RESPONSE TO NRC QUESTIONS
ON PALO VERDE
SEISMIC HAZARD ANALYSIS

Arizona Public Service Company
Phoenix, Arizona

Risk Engineering, Inc.
Golden, Colorado

April 7, 1993

Figure 1. Seismic Source Zones (350 km radius)
for the PALO VERDE Site
recommended by NRC

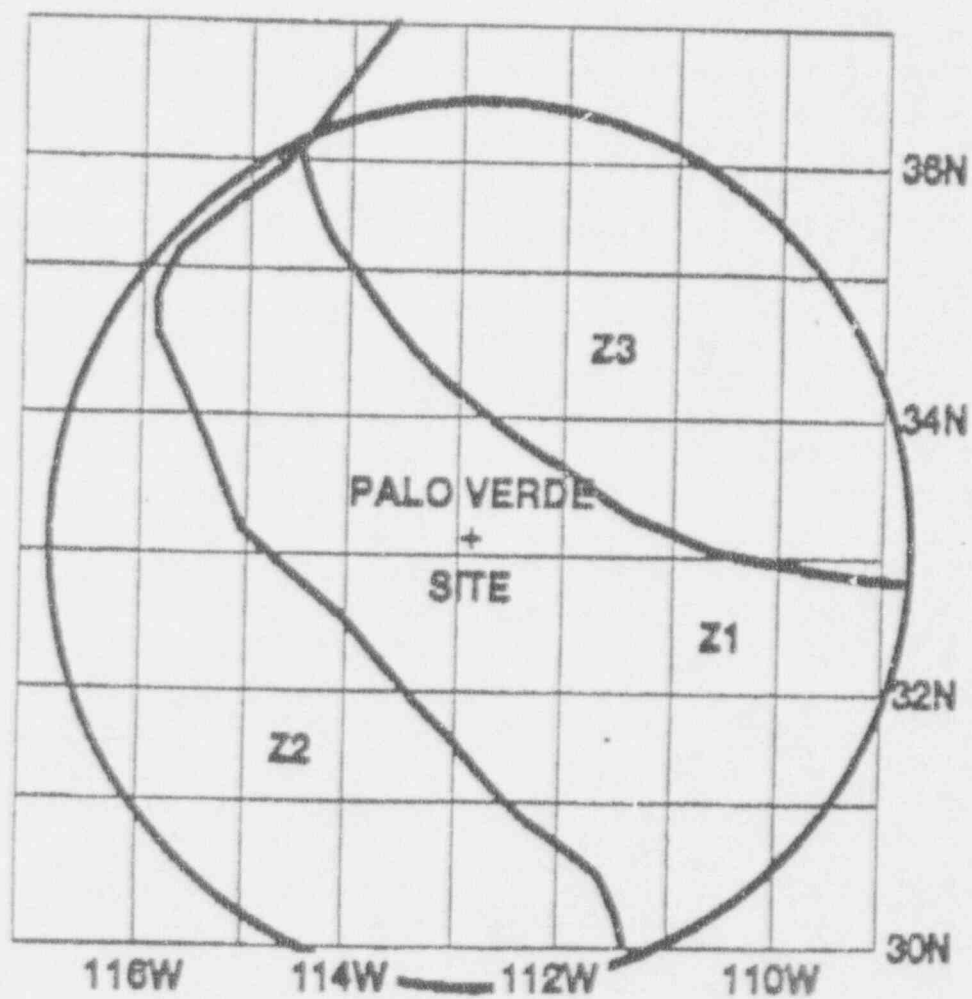
Sensitivity Study II-1 (Seismic Zonation): "In the staff's review (Ref. 2) of the original probabilistic seismic hazard study, submitted by the licensee (Ref. 1), the staff stated that the seismic zonation used in the hazard analysis were not considered to be adequate. (The seismic source zones exclude higher seismicity to the southwest and northeast.) The supplemental hazard analysis submitted by the licensee on August 4, 1992 (Ref. 3), did not consider any additional seismic zonation. We have consulted studies published by the U.S. Geological Survey (USGS) and other investigators and we conclude that there are enough differences in expert opinion, with respect to the seismicity and zonation of the Palo Verde site region, to warrant additional sensitivity studies. To ascertain the sensitivity of the seismic hazard to variations in seismic zonation and activity rates we request that the licensee do an additional calculation using the zonation and activity rates specified in Table 1 and Figure 1 and include in this calculation, faults identified by the Geomatrix team together with their activity rates (Ref. 3, Supplemental Report, Table 4-2)."

The NRC sources and parameters were used to calculate seismic hazard at Palo Verde. In this calculation, the range indicated for the b-values was divided into three equally spaced representative values, each value being weighted equally. Table 2-1 summarizes the parameter values used and associated weights. Similarly, the range of activity rates was divided into four representative values, and the range of maximum magnitudes was divided into five representative values, all values being weighted equally. The base-case site amplification factors were used. The Geomatrix faults were not included in the calculation, in order not to obscure the comparison of hazard results. The calculated hazard from the NRC sources is shown in Figures 2-1 through 2-6 for PGA and the five frequencies considered. Specific hazard values are shown in Table 2-2, and the percent change in hazard (NRC sources divided by base case) is shown in Table 2-3. The NRC sources indicated lower hazard than the median base-case results at all frequencies, and the addition of the Geomatrix faults would not change this conclusion. This follows because the Geomatrix faults do not contribute significantly to the hazard for frequencies of 2.5 Hz and higher (see Figures 6-1 and 6-3 of the Revised Palo Verde Seismic Hazard Report; Reference C). At the frequency of 1 Hz (Figure 6-2 of Reference C) the Cerro Prieto fault and Laguna Salada faults are important contributors, but the combined mean hazard from the NRC sources and the Geomatrix faults is below the mean base-case hazard presented in Figure 6-27 of Reference C, for all amplitudes of interest. Therefore, we conclude that the use of the NRC sources and Geomatrix faults would lead to lower estimates of seismic hazard than have already been calculated in the Revised Palo Verde Seismic Hazard Report (Reference C).

Figure 3-1: Soil amplification for various soil-property models; PGA

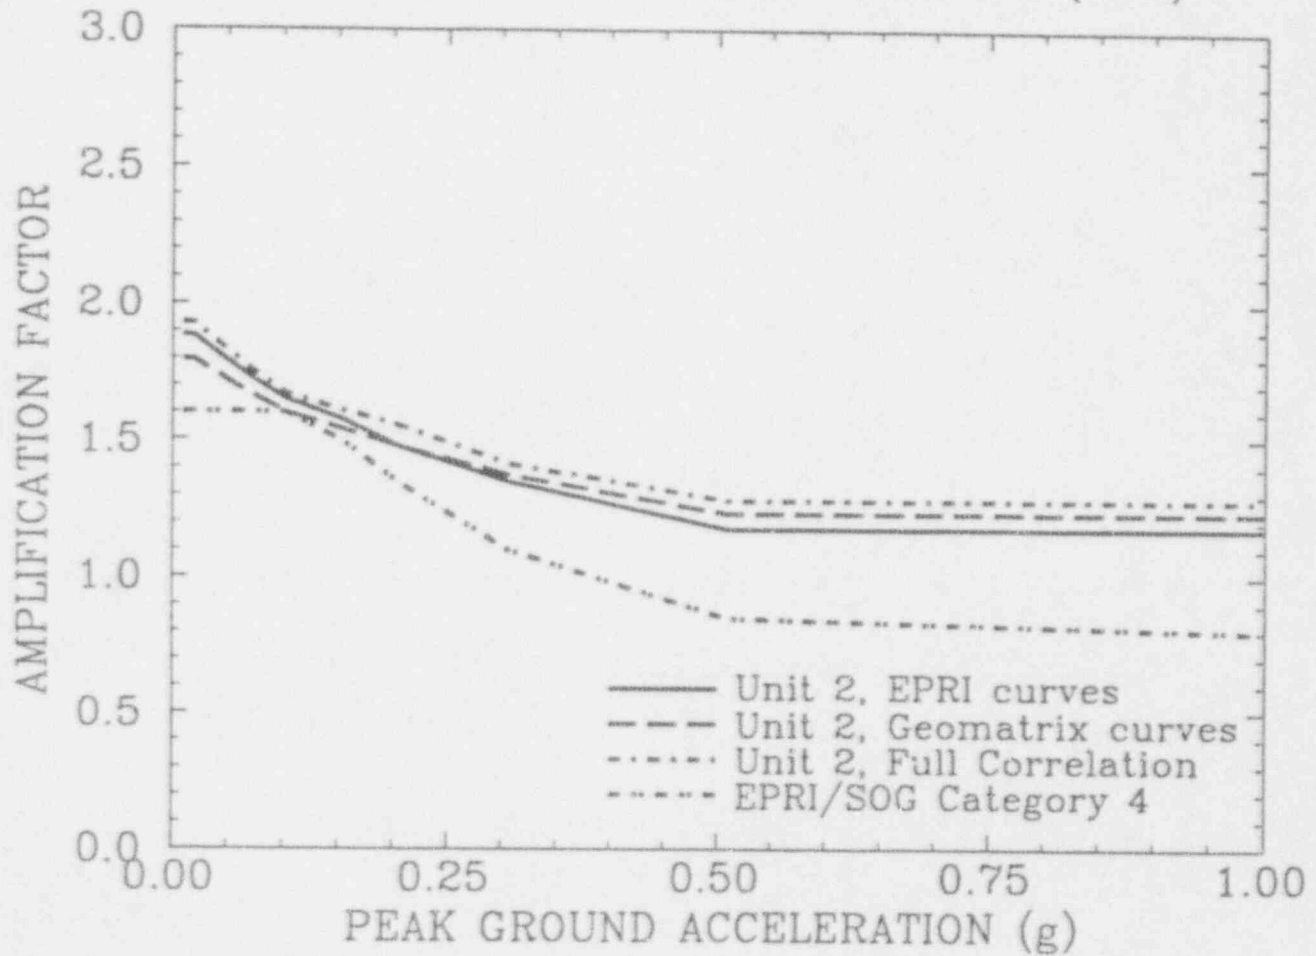
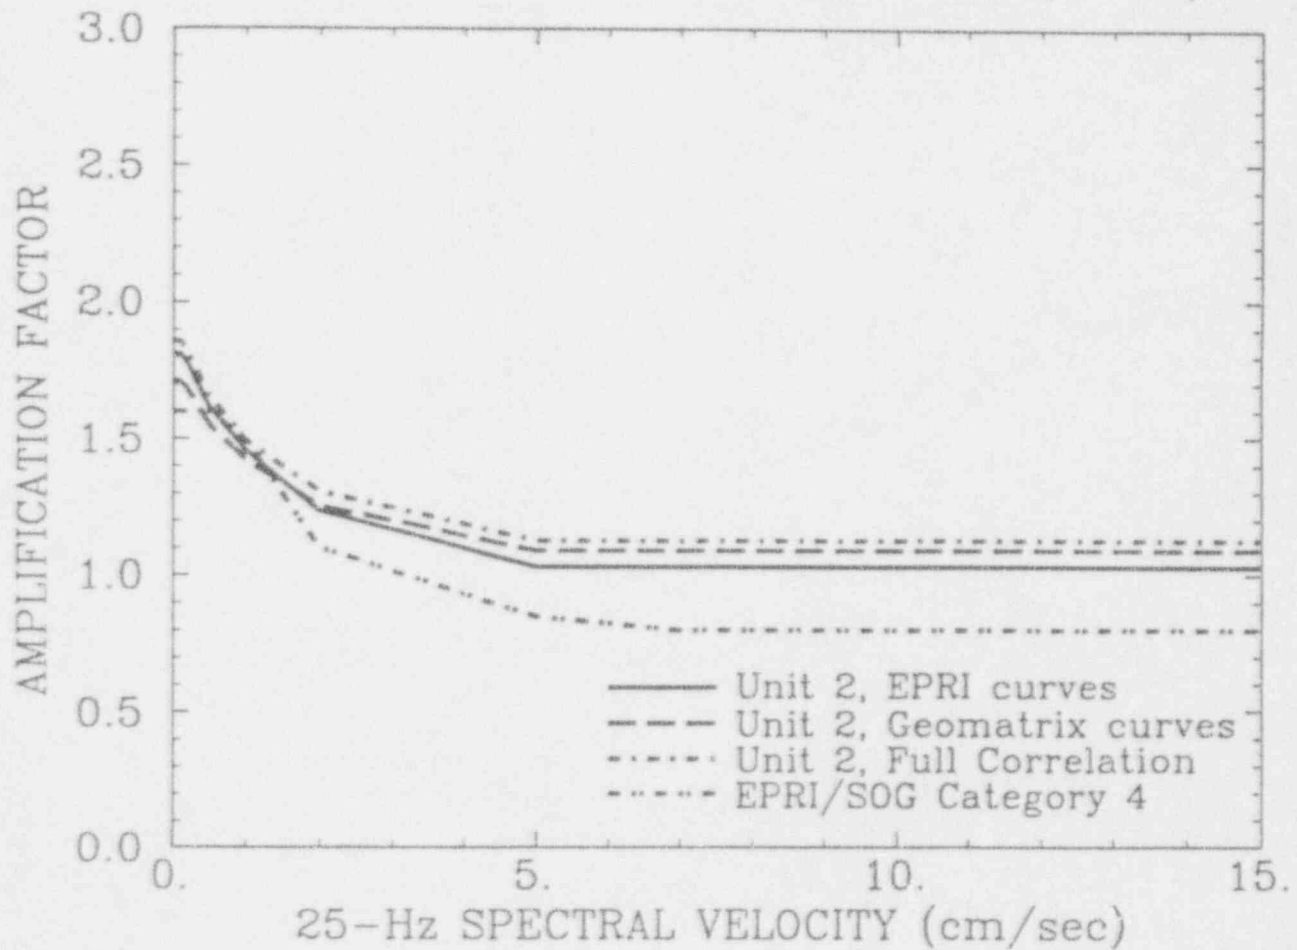
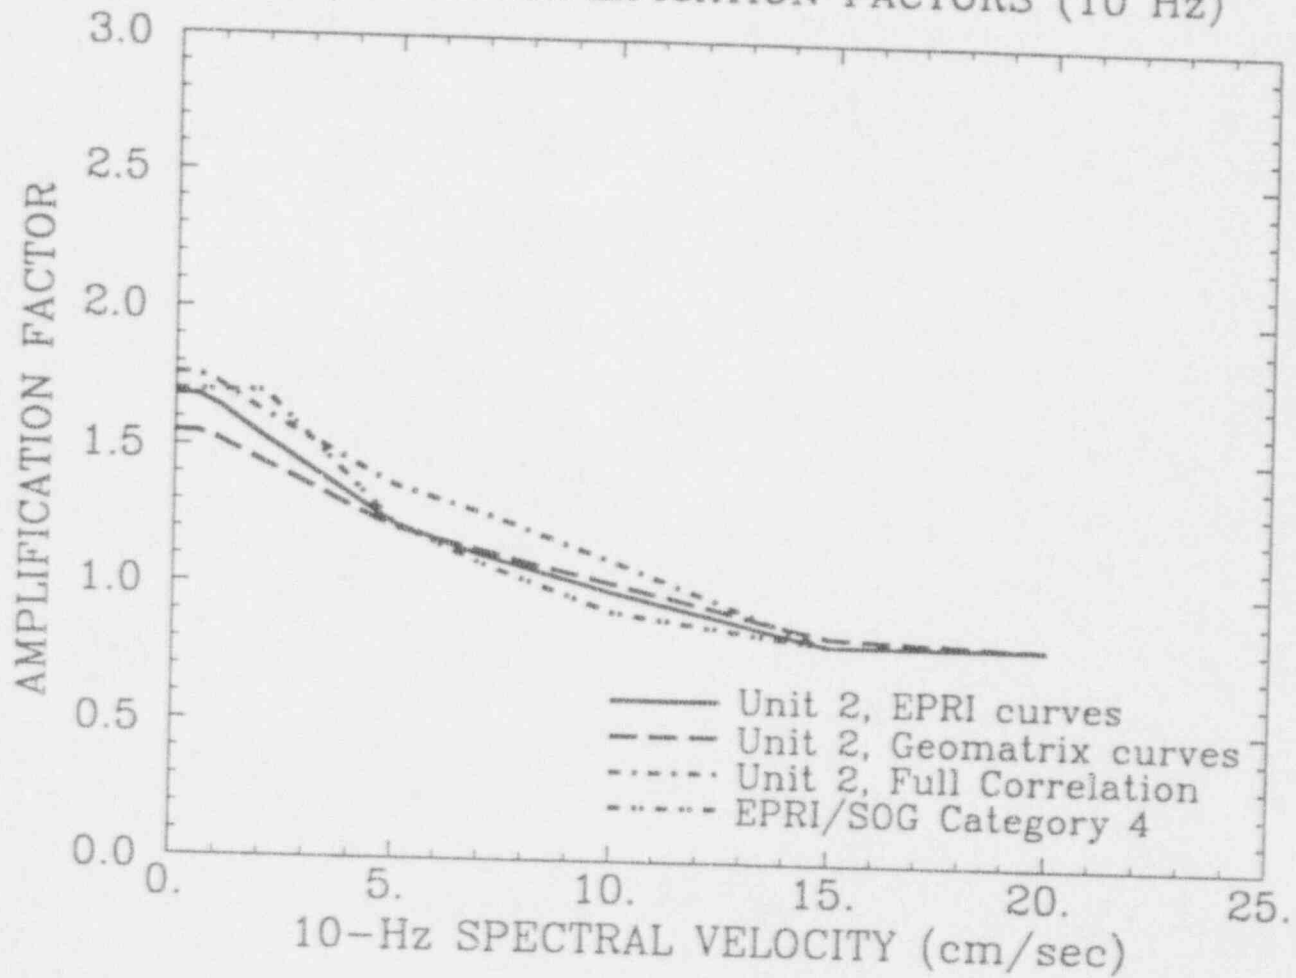
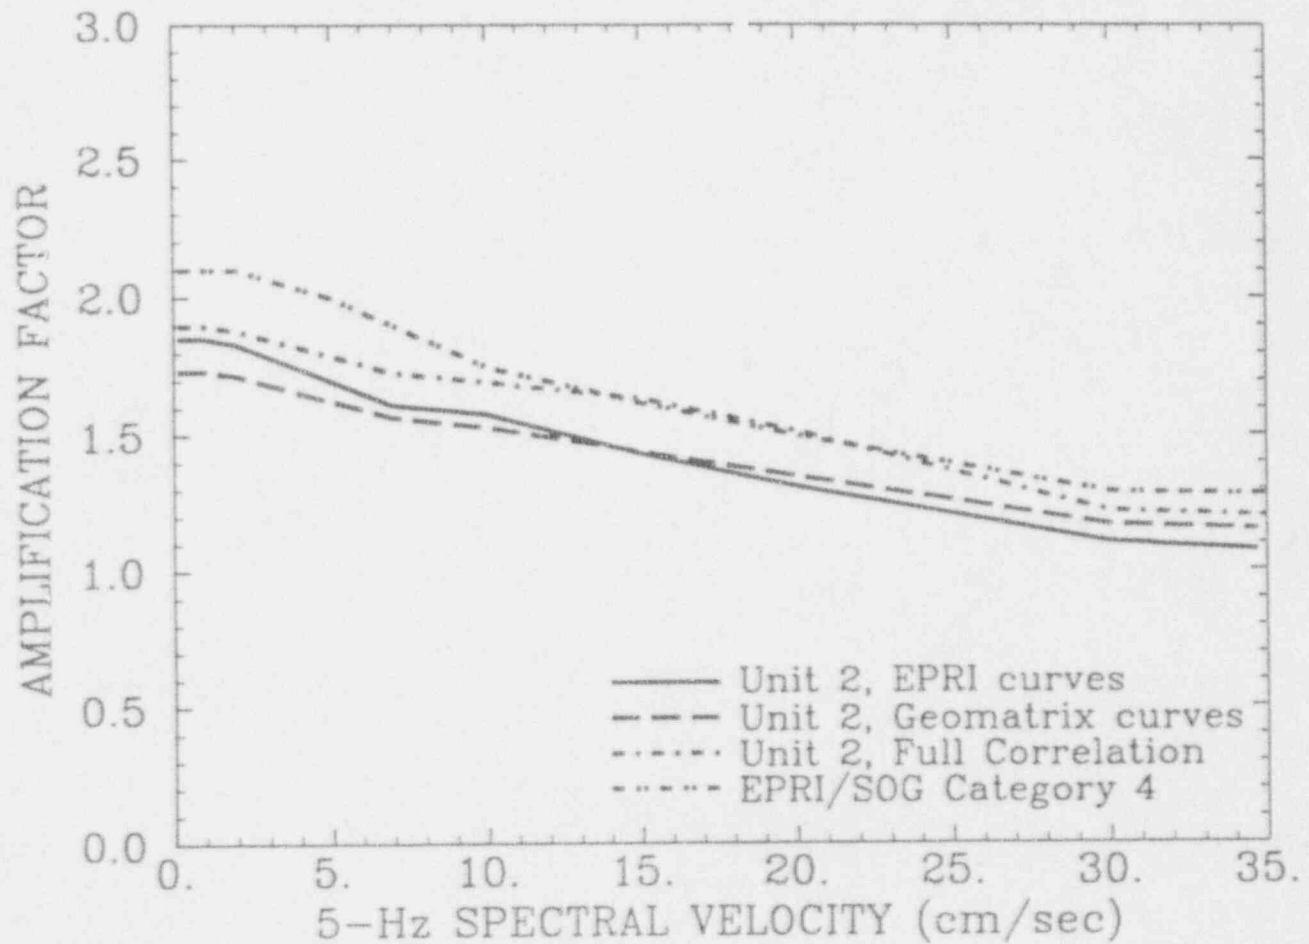
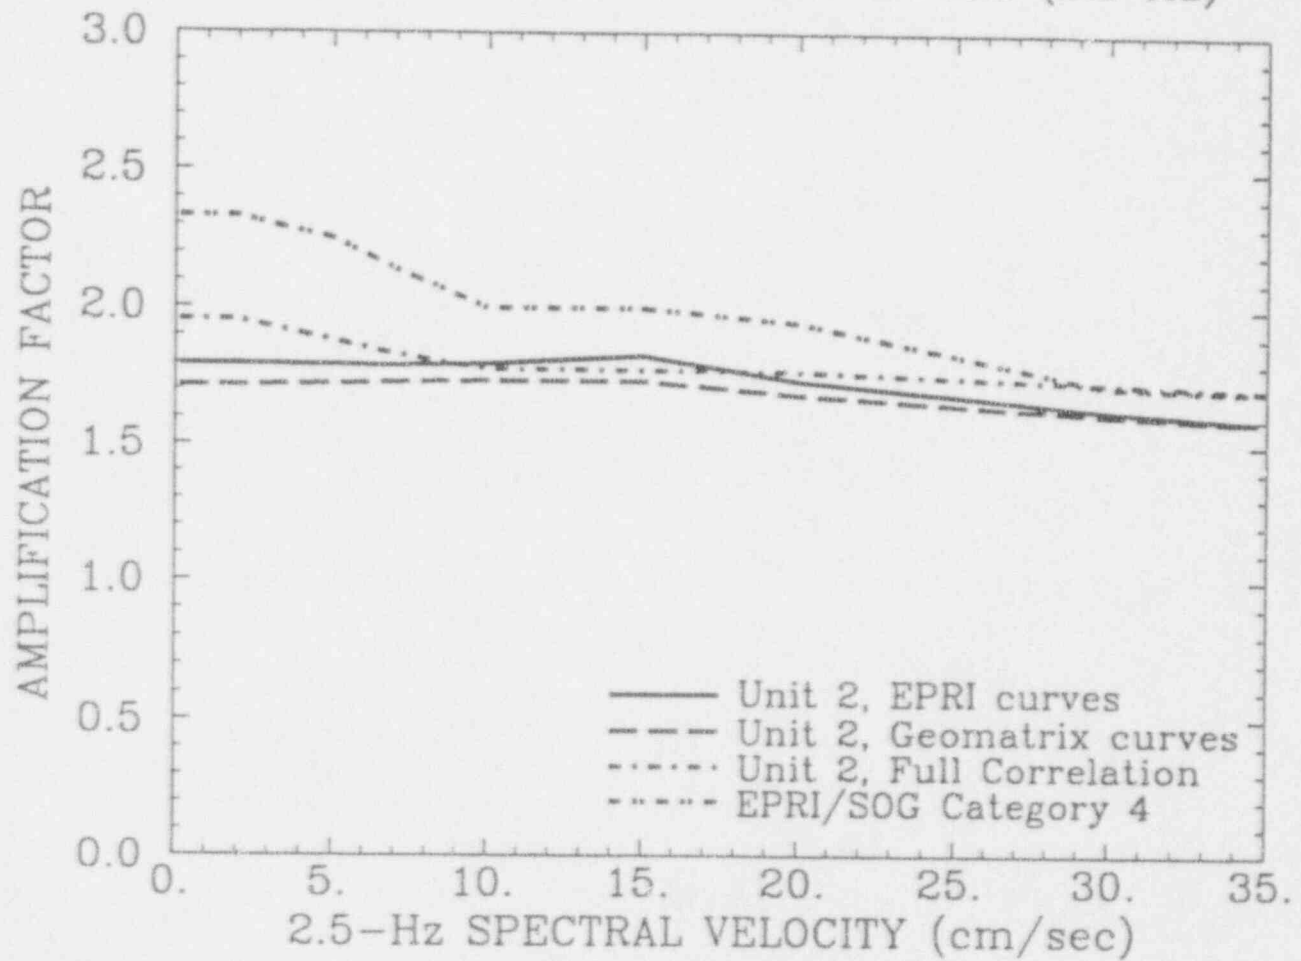
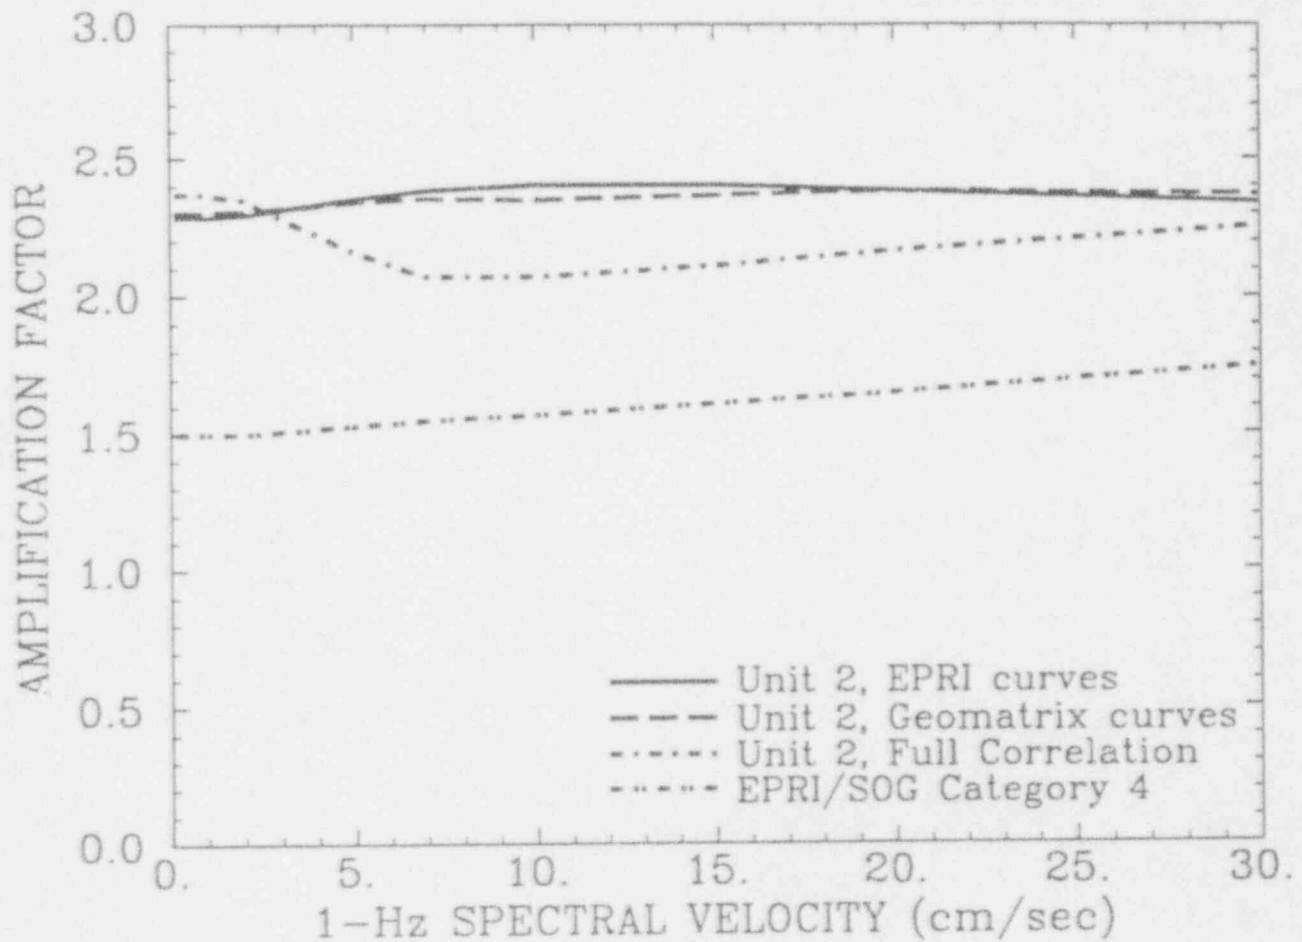
Question II-3 (Soil Characteristics): "The supplemental study (Ref. 3) uses the modulus reduction and damping curves developed by Seed and Idriss and a "Standard Soil Profile." The staff recommends that a sensitivity study be performed using the range of shear degradation models shown in Figure 2 and that it assesses the influence of using the upper range and lower range of the soil profiles shown in the supplemental report (Ref. 3, Supplemental Report, Figure 2-2)."

To determine the effect of different modulus and damping curves, the soil/rock amplification was computed for the range of frequencies and amplitudes used in this study. Figures 3-1 through 3-6 compare these amplification factors. The solid line (labelled "EPRI") is the base case amplification used in the Revised Palo Verde Seismic Hazard Report (it makes use of soil material properties developed during a recent EPRI study, and uses the Unit-2 velocity profile as described in Reference C; Revised Palo Verde Seismic Hazard Report). The dashed curve uses the Geomatrix material properties; these amplifications are below or very close to the base case values at all frequencies, meaning that the use of the Geomatrix curves would not substantially change the results presented in the Revised Palo Verde Seismic Hazard Report.

The curves labeled EPRI/SOG Category IV in Figures 3-1 through 3-6 indicate the amplifications from the EPRI/SOG Category IV amplification factors (i.e., using the 1988 EPRI/SOG profiles, modulus, curve, and damping curve shown in Figures 2-2 and 2-3 of Reference D). The EPRI/SOG amplification factors are generally below the base case except for 2.5 and 5 Hz, where they indicate higher amplification (this is the profile referred to in Question II-3). To determine the effect on hazard, these amplification factors were used to compute hazards at Palo Verde, and the results are shown in Figures 3-7 through 3-12 for PGA and the five frequencies. Quantitative probabilities are presented in Table 3-1, and percent changes in hazard (probability) are presented in Table 3-2.
